BT/BG
15629
18 February 2016

**MODIFICATION TO MP 08_0153 – STAGE 2
PROJECT APPLICATION APPROVAL – NEUROSCIENCE RESEARCH PRECINCT**

Figure 2 – East Elevation
Source: Cox Richardson Architects

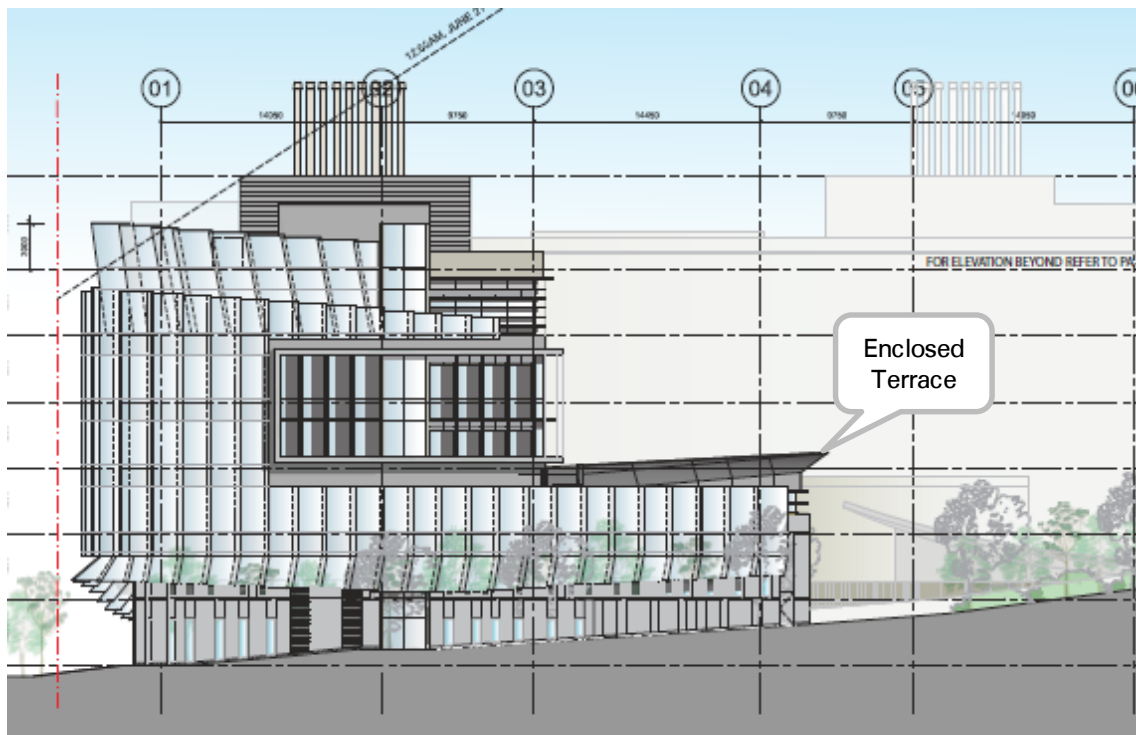
The extent of the proposed modification is shown in the Architectural Plans prepared by Cox Richardson Architects and is included at **Appendix C**. The maximum height of the new roof plane will not exceed 58.850m AHD. **Figure 2** shows the enclosed terrace as viewed from the east.

The proposed modification for the enclosed terrace is a single storey component on level 3, and is confined to the terrace area. It would not extend beyond the approved building envelope. The roof will be a metal grey colourbond material and will have a maximum of 58.850m AHD and will present as a sculpted, projecting roof form.

The enclosed terrace will be setback from the eastern edge of the terrace, behind and detached from the existing glazed façade screen and the scale will be proportionate to the existing scale and massing of the development. The additional GFA is minor and will not significantly alter the overall bulk and scale of the approved development as the proposed modification is contained wholly within the overall Stage 2 building envelopes, as approved.
